Project:	<b>Hanging Heaton, Batley</b>	Doc No:	<b>24004-LE-ZZ-05-RP-D-0001</b>
Subject:	<b>Drainage Strategy</b>	Rev:	<b>P01-S2</b>
Prepared by:	<b>M Fenton</b>	Date:	<b>26/06/2024</b>
Approved by:	<b>W Farrell</b>	Date:	<b>26/06/2024</b>

Lynas Engineers have been appointed by Mandale Homes to undertake a drainage design to support a planning application (ref 2023/93597) for the 'Hanging Heaton' residential development in Batley.

**Consultation Response from KC,  
Lead Local Flood Authority**

**2023/93597 east of, Mill Lane, and Heaton Grange, Hanging Heaton, Batley, WF17 6EN**

Title: **PROPOSED LEVELS GA**

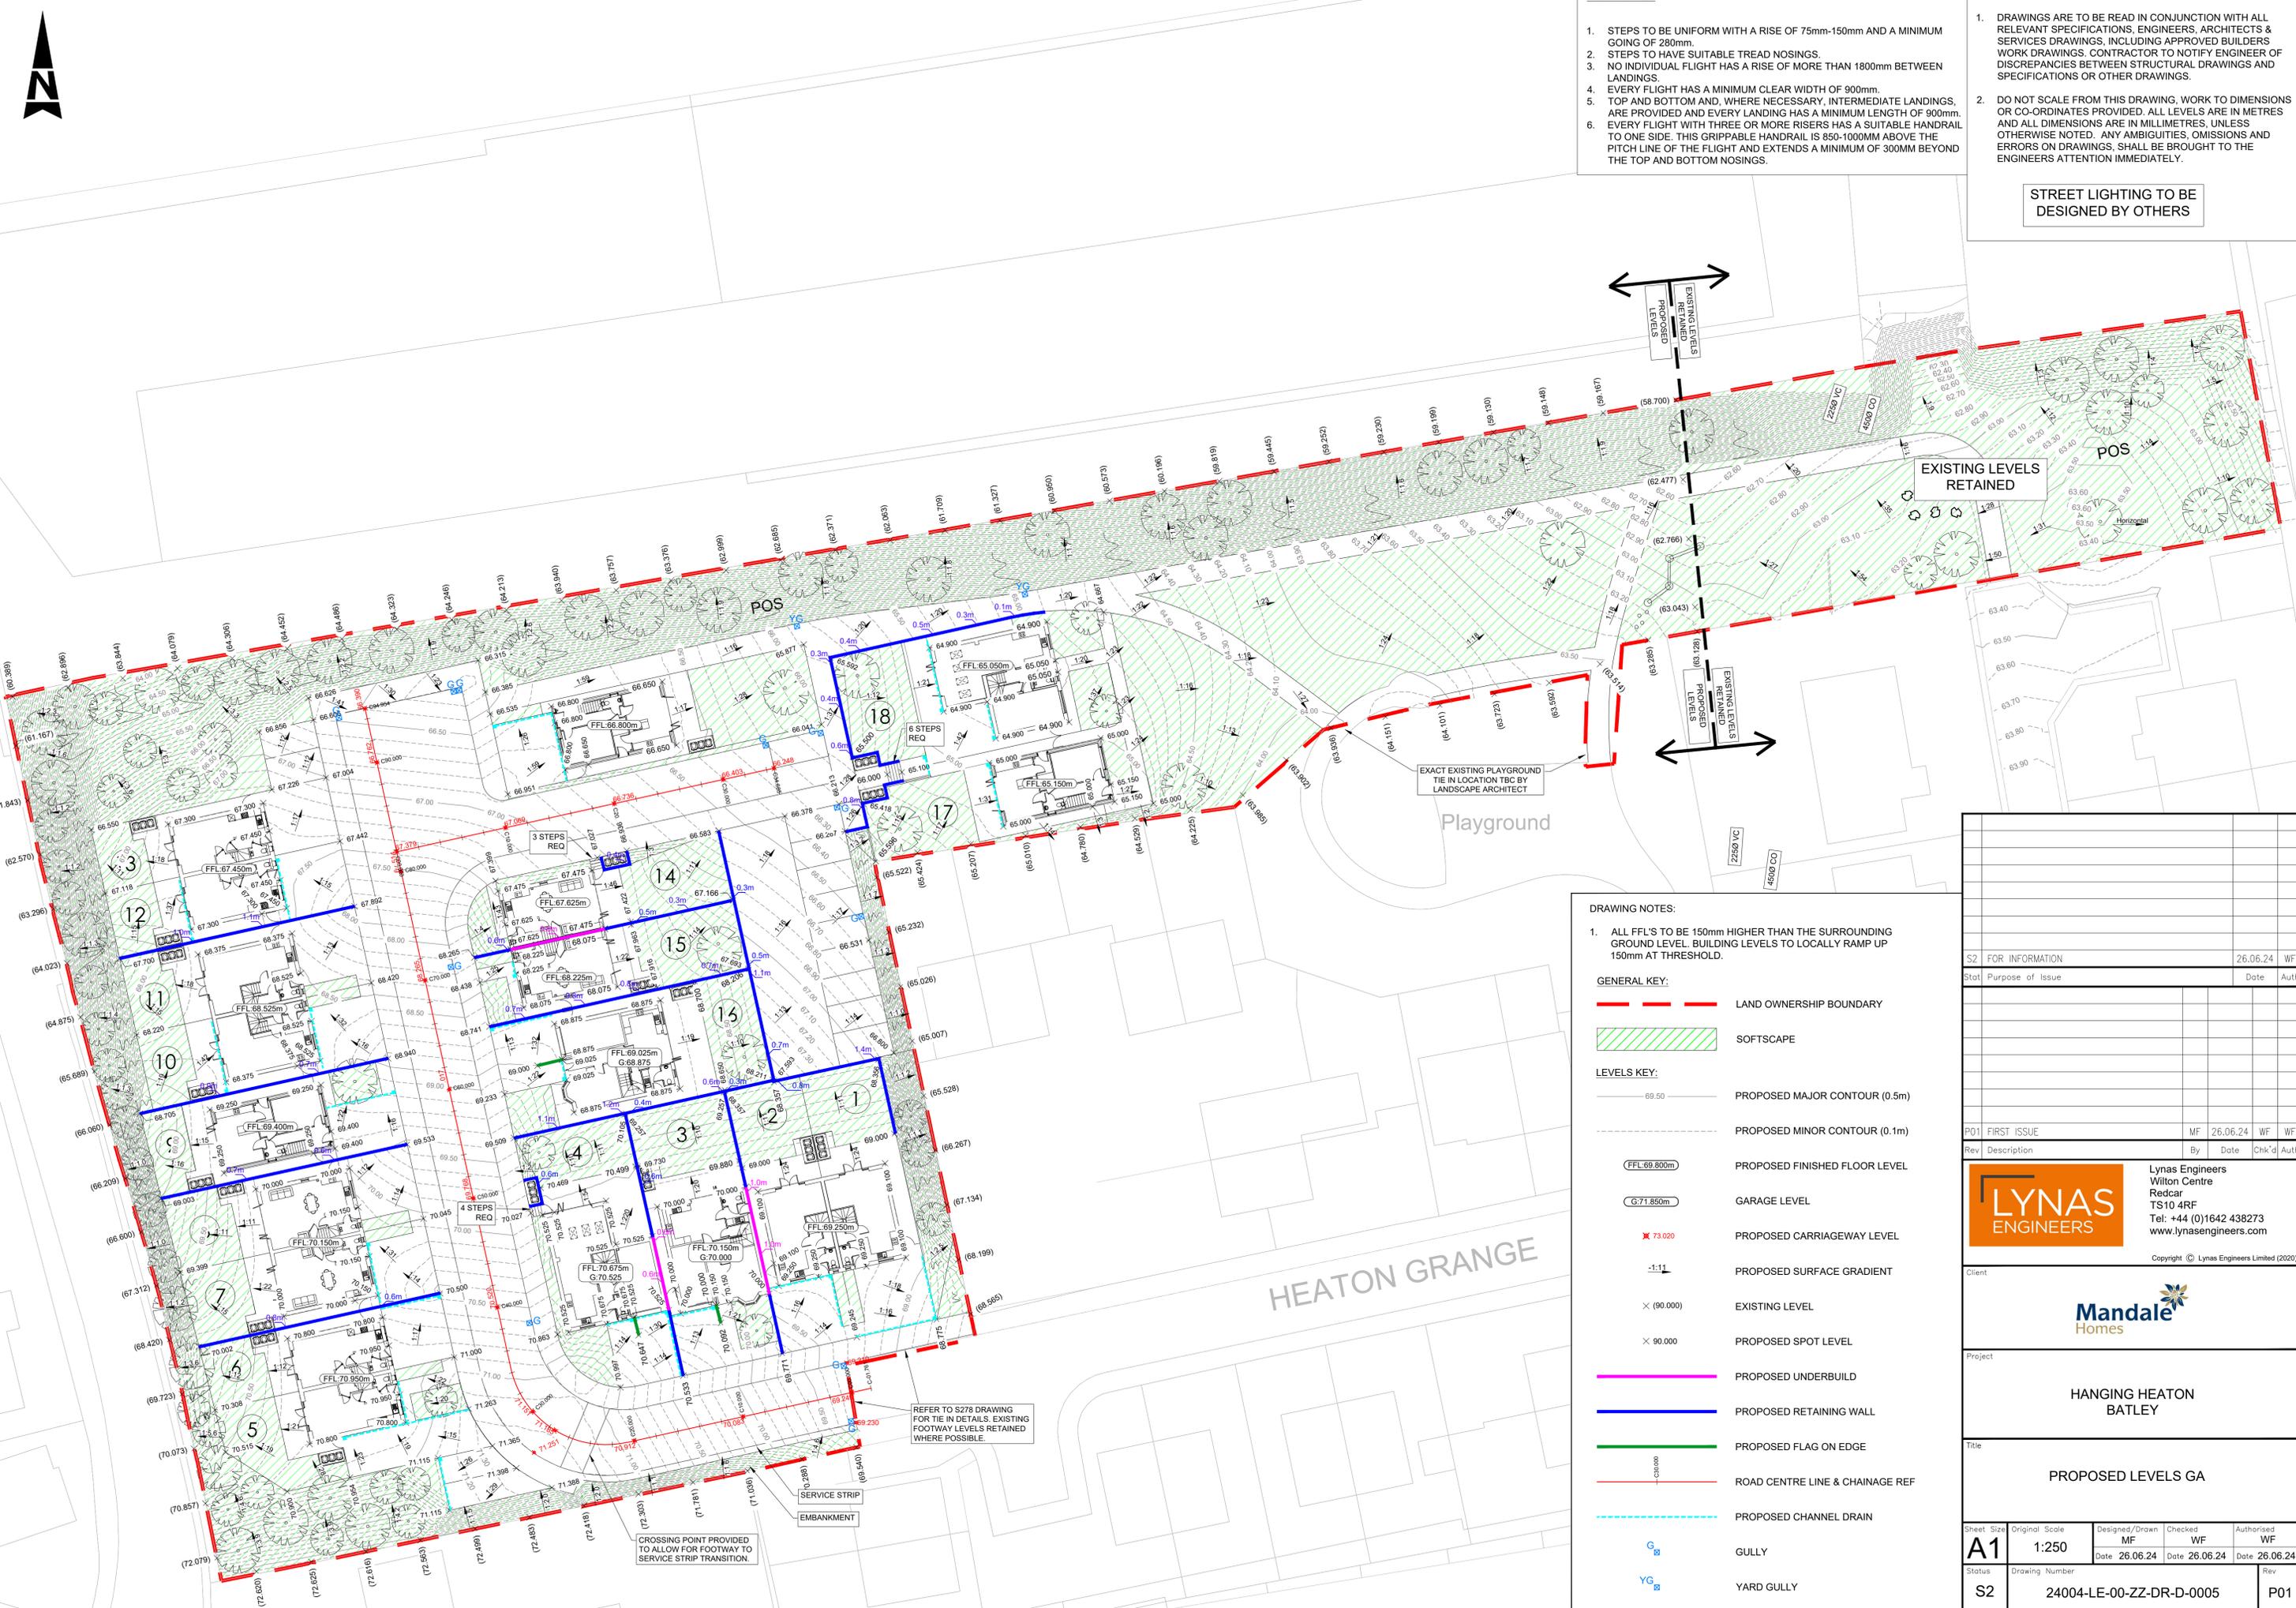
The 'Site Location & Existing Ground Levels' drawing (Appendix A) show the existing site levels falling from south north. The 'Proposed Levels GA' drawing (Appendix C) also shows the site levels falling from south to north. The proposed works will result in no significant changes to the exceedance flood routing through the site. Additionally, it can be seen on the 'Site Sections' drawing (Appendix C) that the proposed roads contain no sags and will not trap water, which is often a flood risk for low lying properties.

Title: **PROPOSED DRAINAGE GA**

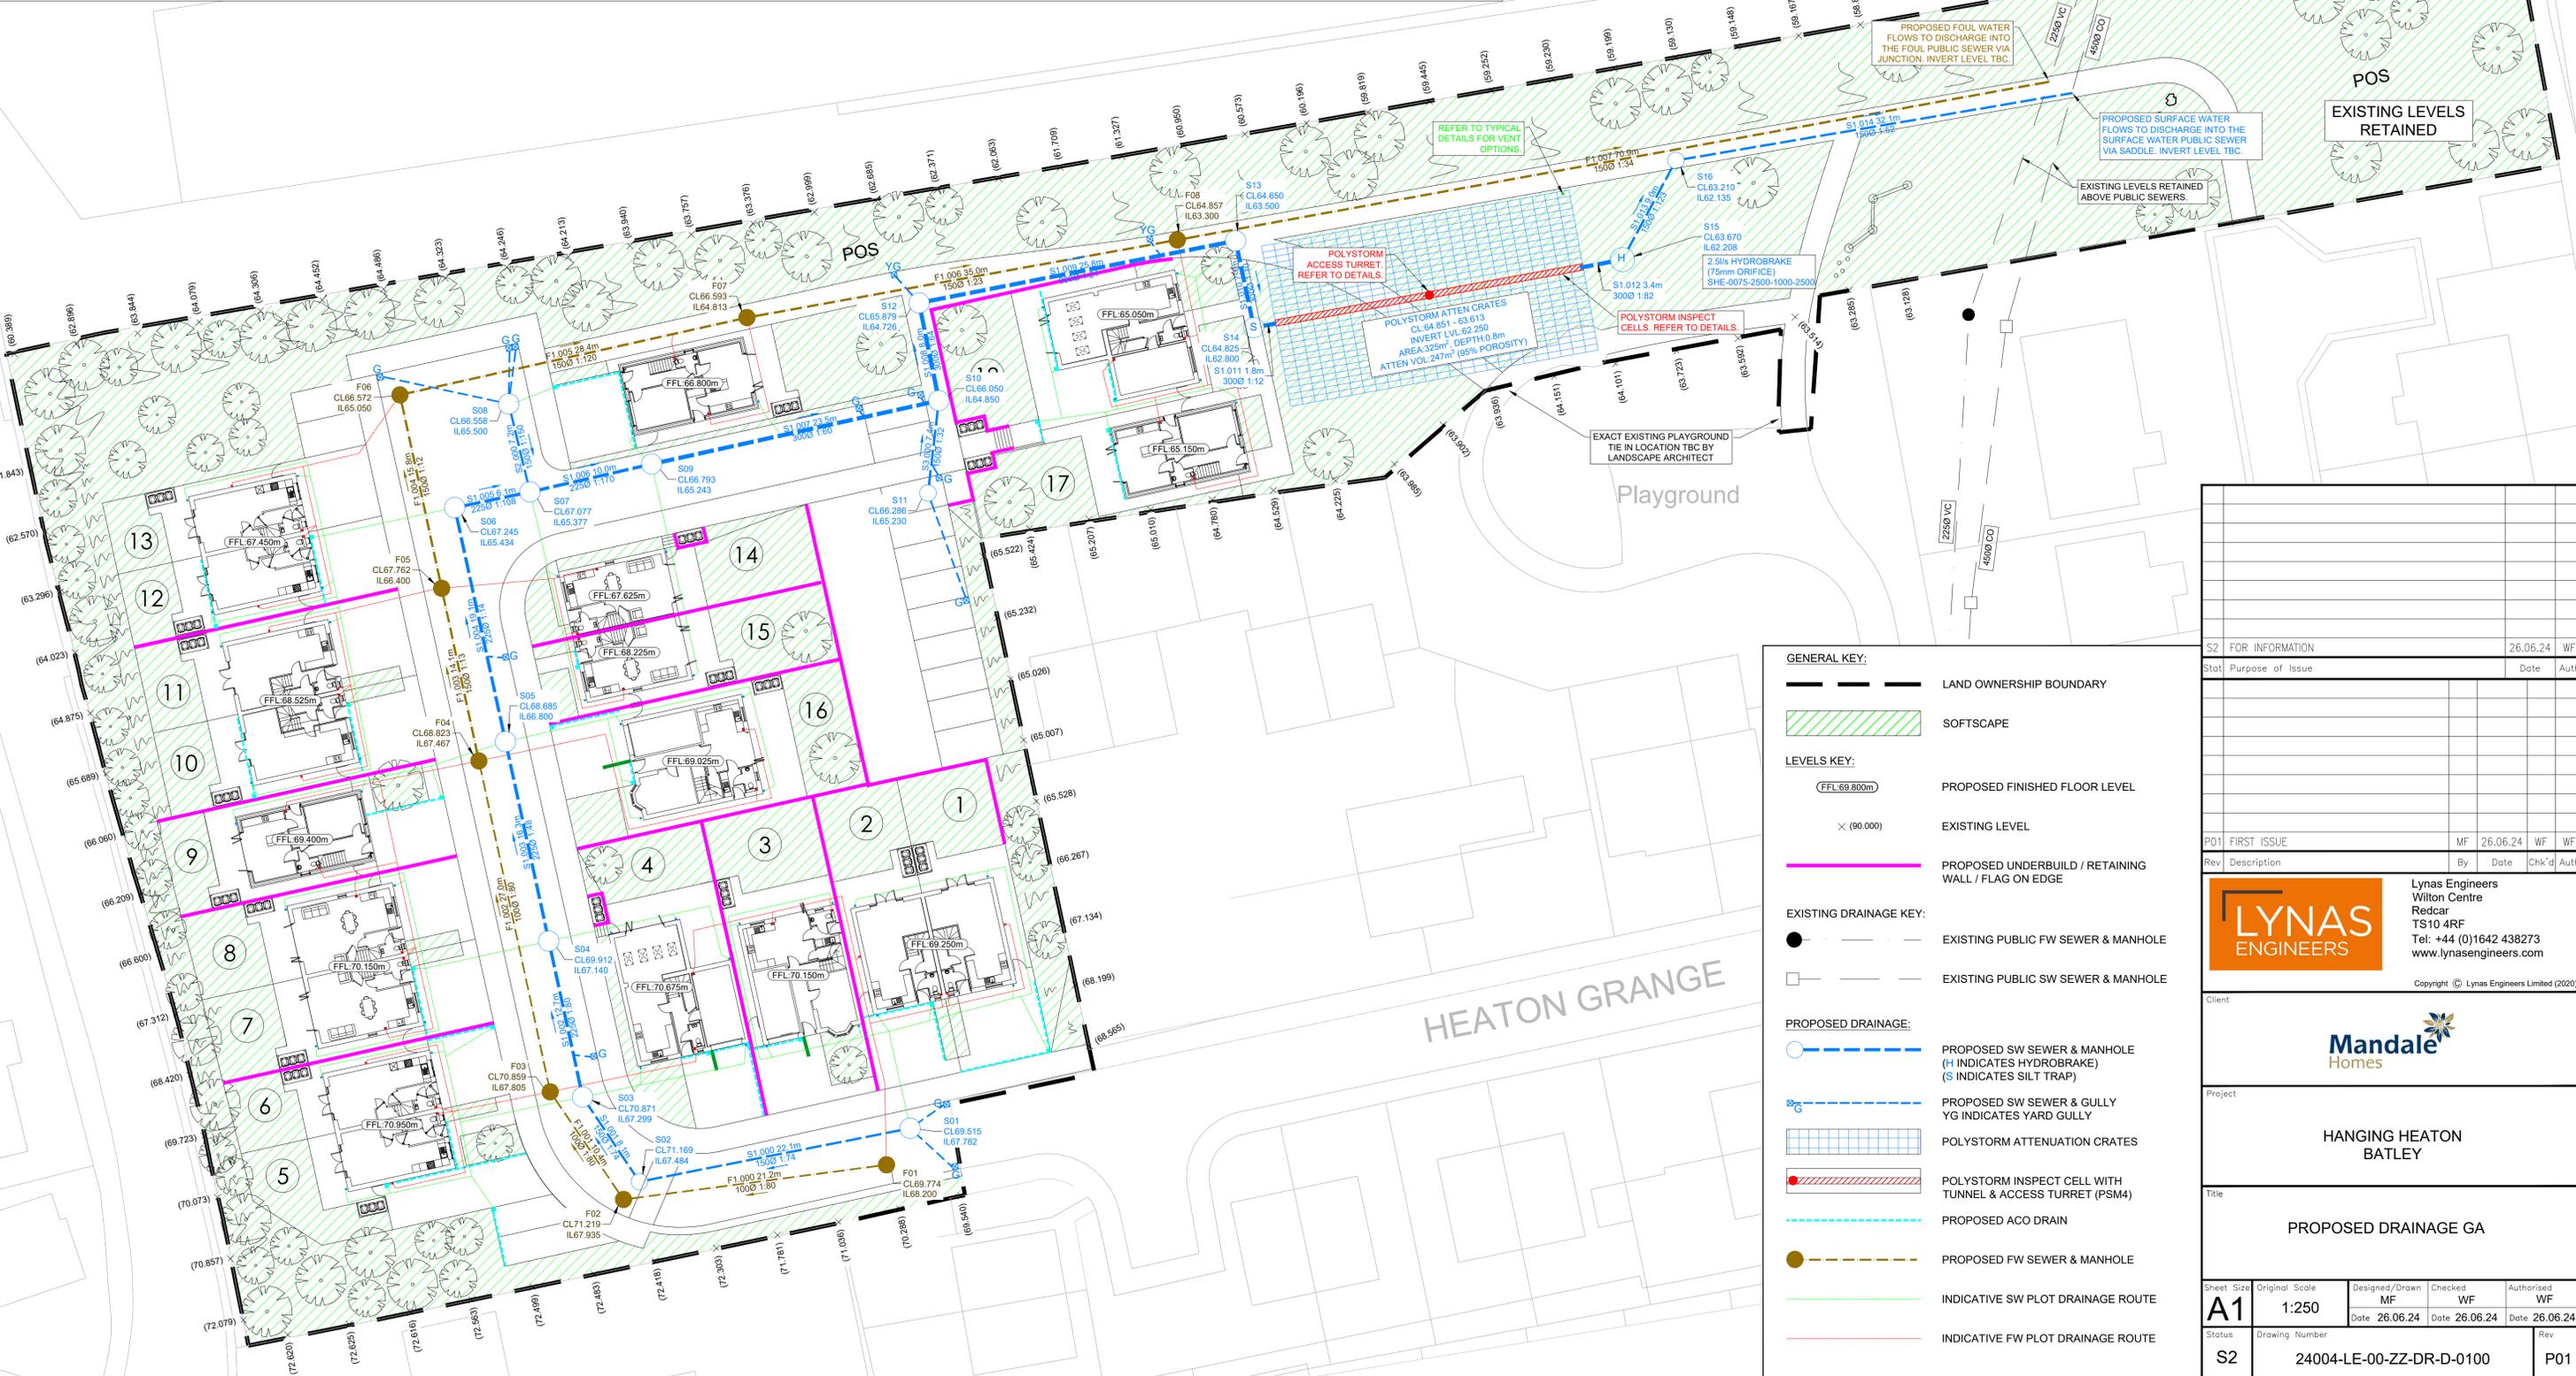
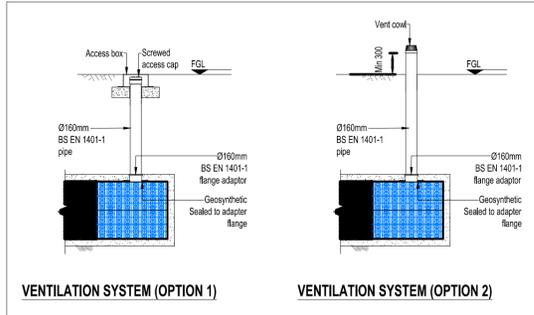
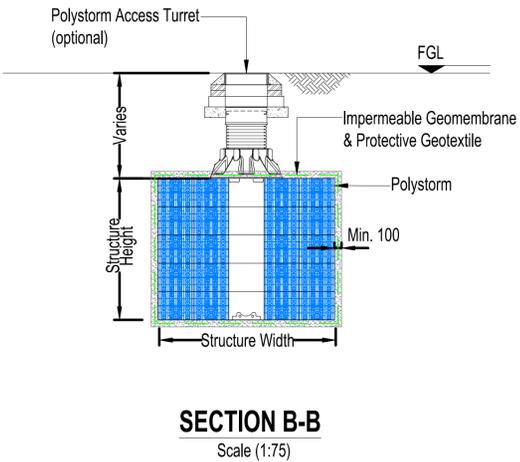
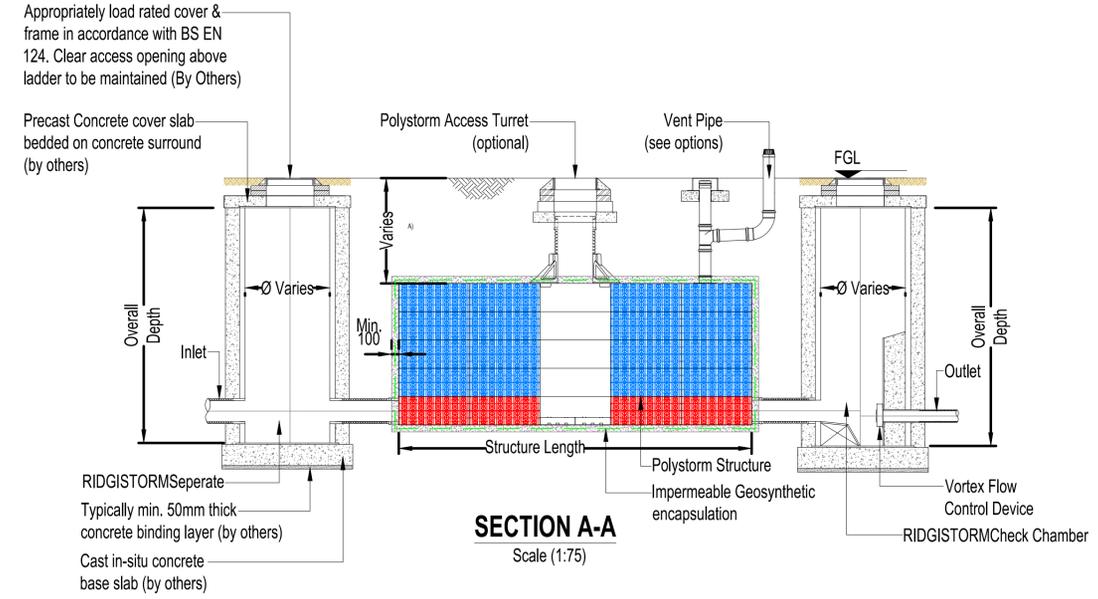
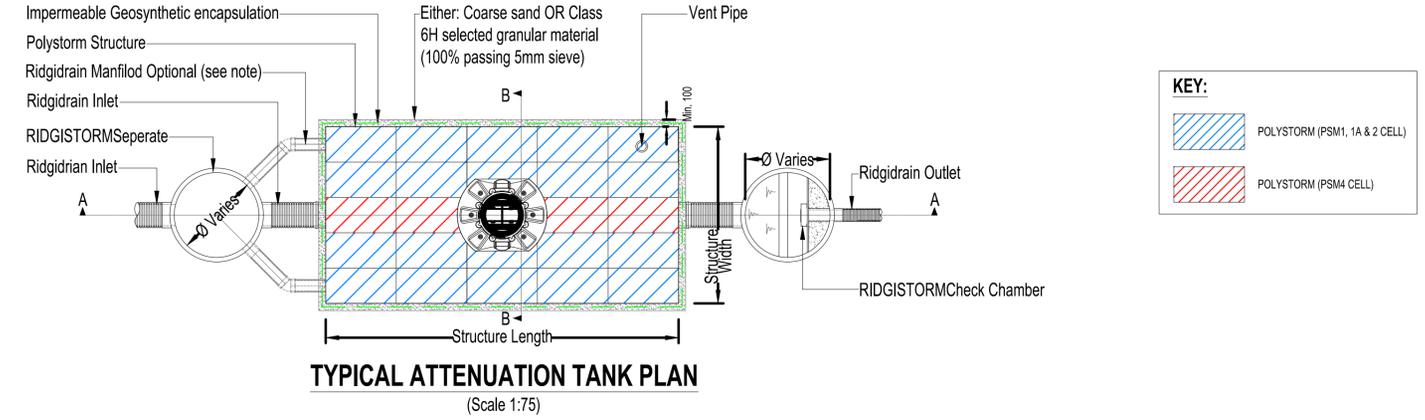
- Detailed design scheme including attenuation construction details/design, plans and longitudinal sections. **Refer to design drawings in Appendix C.**

- The submitted drawing should show surface water storage and flow control rate. **Refer to the 'Proposed Drainage GA' in Appendix C.**

- Drawing Ref: 24004-LE-00-ZZ-DR-D-0002, Proposed Drainage GA, Rev P01 dated 26/01/24.

The surface water drainage from Plots 2, 3 & 4 should not connect directly into the MH in the road as the angle of deviation of the flow would be greater than 90 degrees. The drain should instead connect to the drain running parallel to Plot 4.

- a) evidence should be submitted to show that other (than discharge to public sewer) means of surface water disposal have been considered and why they have been discounted
- b) the submitted drawing should show surface water storage and flow control rate
